PRODUCT CHANGE NOTICE
PCN Form (D4-E000-73)

PCN#07-003

NOTIFICATION DATE: March 19, 2007

Case Styles: DZ883, DZ885, DZ943, DZ944, DZ1034
Model Prefixes: MCA, MCA1, SCA, QBA, BDCA, BDCA1

DZ883

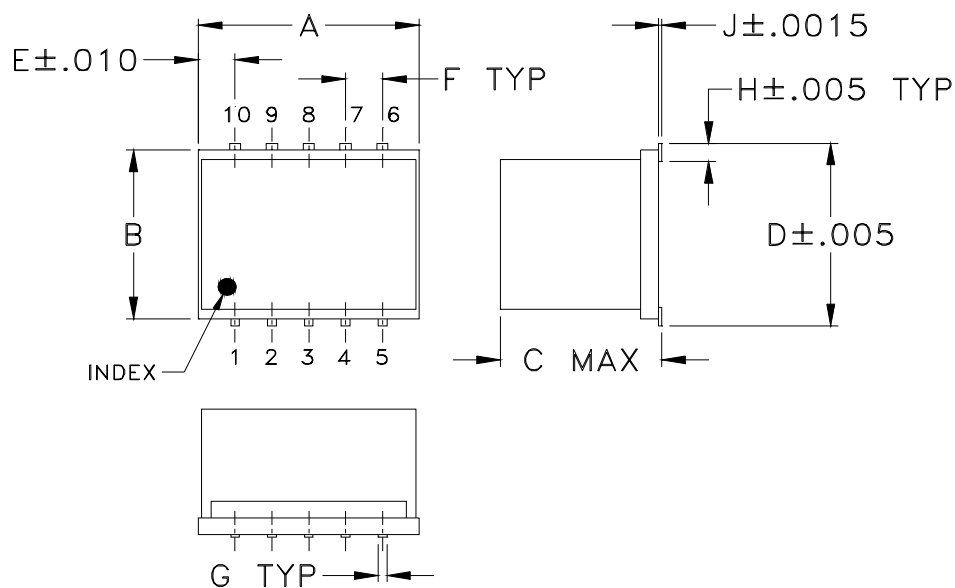
<i>Existing</i>	<i>New /Change</i>
<i>Dimension D</i>	<i>0.262 inch/6.66 mm, +/-0.006"</i>	<i>0.266 inch ±.005"</i>
<i>Dimension H</i>	<i>0.027 +/- 0.006 inch</i>	<i>0.029 inch ±.005"</i>

To tighten the tolerance of the dimension specifications of the outline drawing.

CASE#	A	B	C	D	E	F	G	H	J	K	L	M	WT. GRAMS
DZ883	.30 (7.62)	.250 (6.35)	.190 (4.83)	.266 (6.76)	.050 (1.27)	.050 (1.27)	.012 (0.30)	.029 (0.74)	.004 (0.10)	.085 (2.16)	.296 (7.52)	.030 (0.76)	0.5
